SUBJECT: UNIVERSITY OF MISSOURI AT COLUMBIA — AMENDMENT
RE: MANAGEMENT ORGANIZATION (TAC NO. MC1601)

AMENDMENT TO AMENDED FACILITY LICENSE

Amendment No. 33
License No. R-103

SAFETY EVALUATION BY THE OFFICE OF NUCLEAR REACTOR REGULATION

Figure 6.0

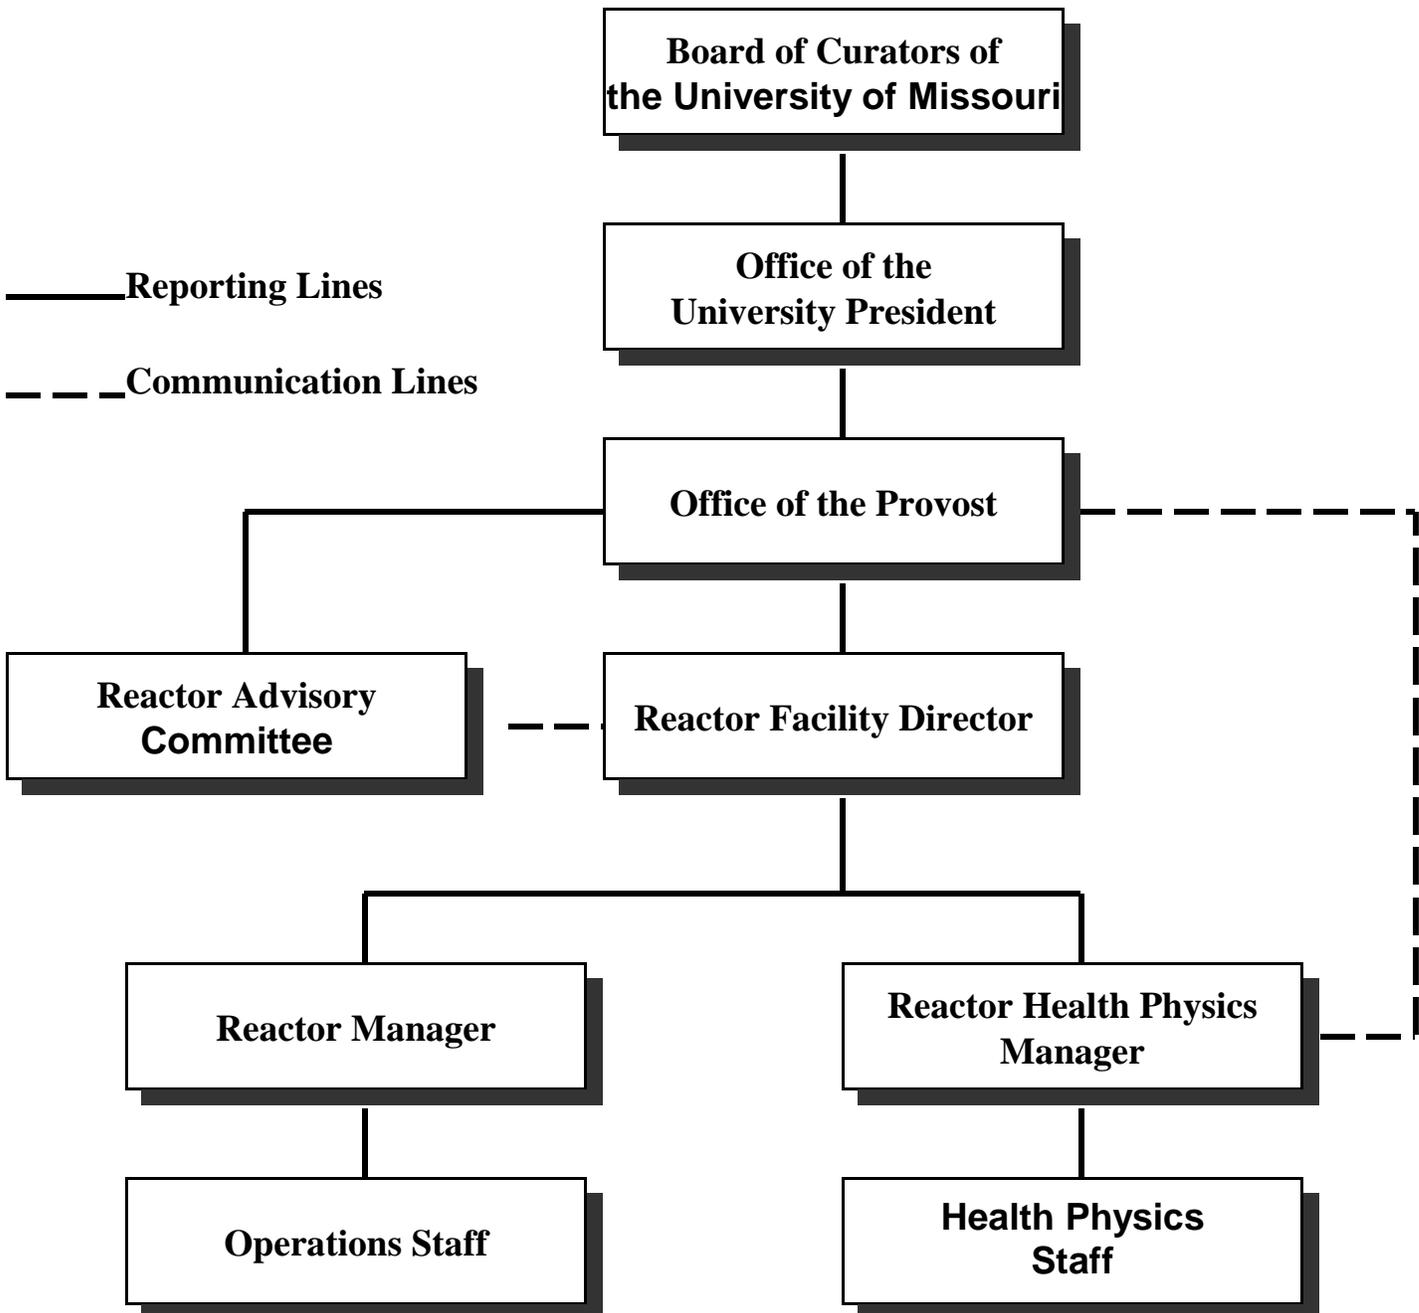
By letter dated December 19, 2003, the Curators of the University of Missouri (licensee) submitted a request for amendment to the technical specifications (TSs) in Appendix A to Amended Facility License No. R-103 for the University of Missouri at Columbia (UMC) Research Reactor (MURR). The requested changes would revise the management organization by removing the Chancellor, UMC, from the organization reporting line.

The licensee shall modify its chain-of-command for MURR to better ensure oversight of its activities by university senior management. It has been agreed that the modification of Figure 6.0 in the MURR Technical Specifications will reflect

MURR reporting to the Office of the Provost, who in-turn, reports to the Office of the President, University of Missouri. The requisite technical specification change shall be submitted to the NRC within 30 days of this Order and upon being granted by the NRC, shall be effective no later than 30 days after the date of the NRC's issuance of the license amendment.

The licensee has submitted changes to Figure 6.0 of the MURR TSs to meet the Order.

Figure 6.0 of the MURR TSs currently has the Reactor Facility Director reporting to the Office of the Provost, which reports to the Chancellor, UMC, who reports to the University President. The University President reports to the Board of Curators of the University of Missouri.

The licensee has proposed removing the Chancellor, UMC, from the reporting chain. The licensee has also proposed that "University President" be changed to "Office of the University President" on the figure.

The licensee's proposed changes to the TSs are consistent with the guidance of the American National Standards Institute/American Nuclear Society (ANSI/ANS) standard 15.1, "The Development of Technical Specifications for Research Reactors" (ANS-15.1). ANS-15.1 is supported by the NRC staff and represents an acceptable approach for developing the administrative requirements section of research and test reactor TSs. The proposed organization is acceptable because university upper management (called Level 1 management in ANS-15.1) continues to have responsibility for the reactor. The elimination of a layer of upper management will focus the responsibility of the remaining levels of upper management.

The NRC staff finds that the proposed changes to Figure 6.0 of the licensee's TSs are consistent with the guidance of ANS-15.1 and meets the requirements of the NRC Order to the licensee. Therefore, the NRC staff concludes that the changes to the licensee's organizational structure are acceptable.
